AMENDMENTS TO THE DRAWINGS

REMARKS

"METHOD AND APPARATUS FOR SECURING A DOOR PISTON TO A DOOR JAMB"

Carmen Grande
Attorney Docket No. 4069-045138
ANNOTATED SHEET

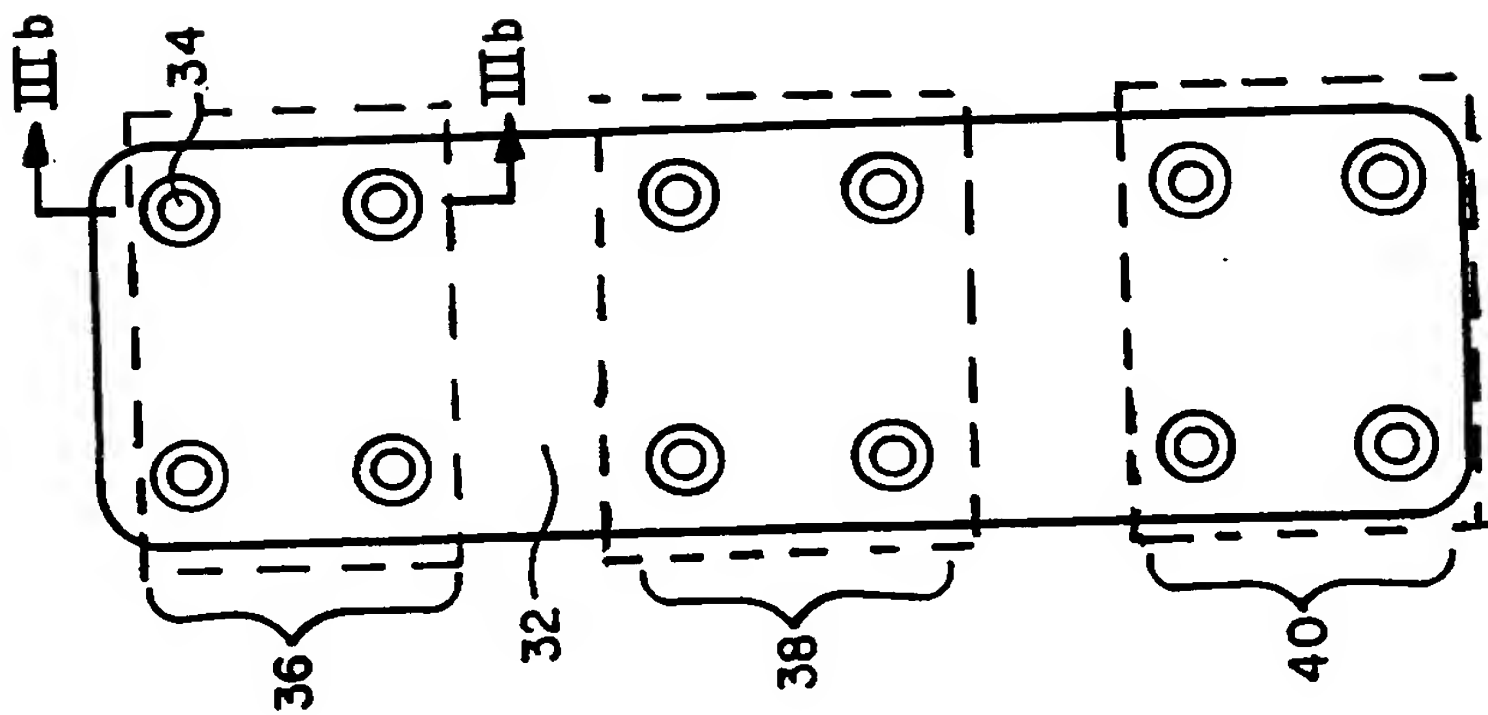
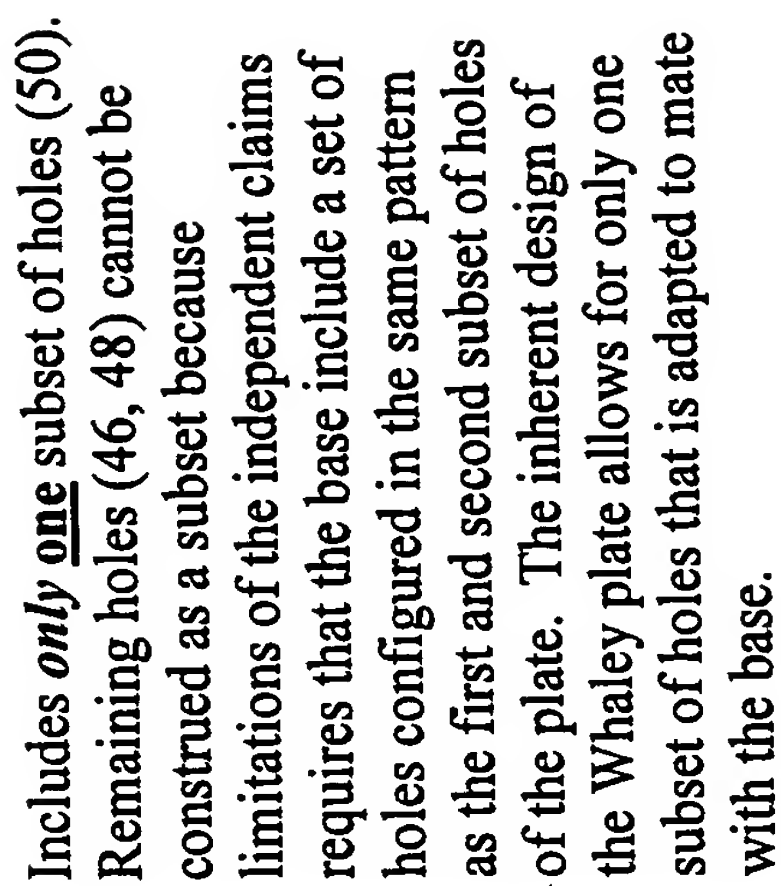
In amended FIGS. 2 and 5, the base (52) has been resized with shifted holes (60) to correspond to the upper and lower set of holes on the plate (32). Thus, the hole pattern on the base (52) corresponds to any subset of hole patterns on the plate (32). The Applicant has submitted formal drawing sheets for FIGS. 1, 2, 3a, 3b, 4a, 4b, 4c, 5, 6, and 7, which include the aforementioned amendments to FIGS. 2 and 5.

The drawings stand objected to because the Examiner asserts that FIGS. 2, 5, and 3a appear to be inconsistent. The Applicant believes that new FIGS. 2 and 5 overcome the Examiner's objections. Amendments to FIGS. 2 and 5 are indicated in red in the attached annotated copy of FIGS. 2 and 5. Reconsideration of these objections is respectfully requested. Entry of formal drawings sheets for FIGS. 1, 2, 3a, 3b, 4a, 4b, 4c, 5, 6, and 7 is also respectfully requested.

APPENDIX A

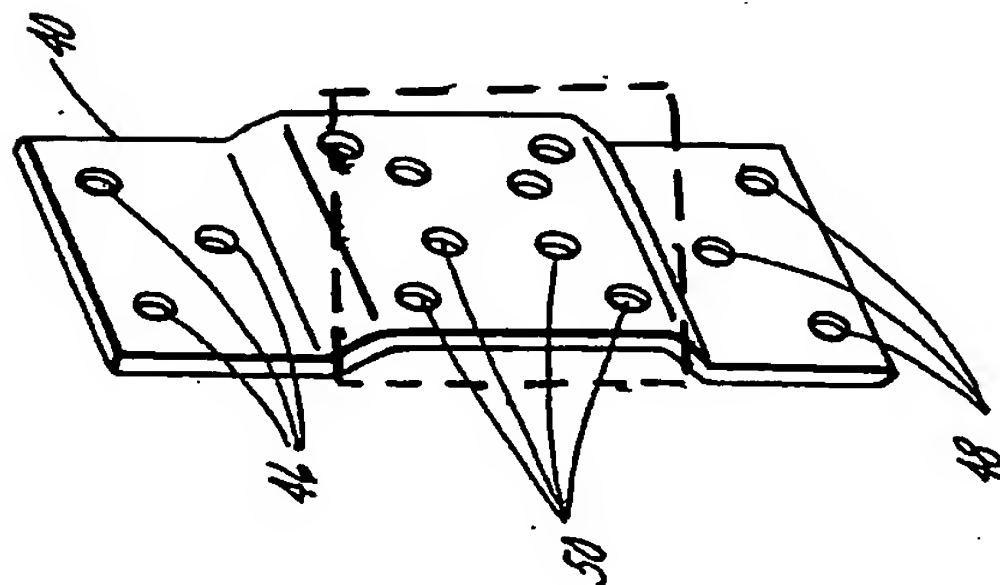
At least a **first** and **second** subset of holes, each subset corresponding to the pattern of holes on the base.

WHALEY

PRESENT INVENTION
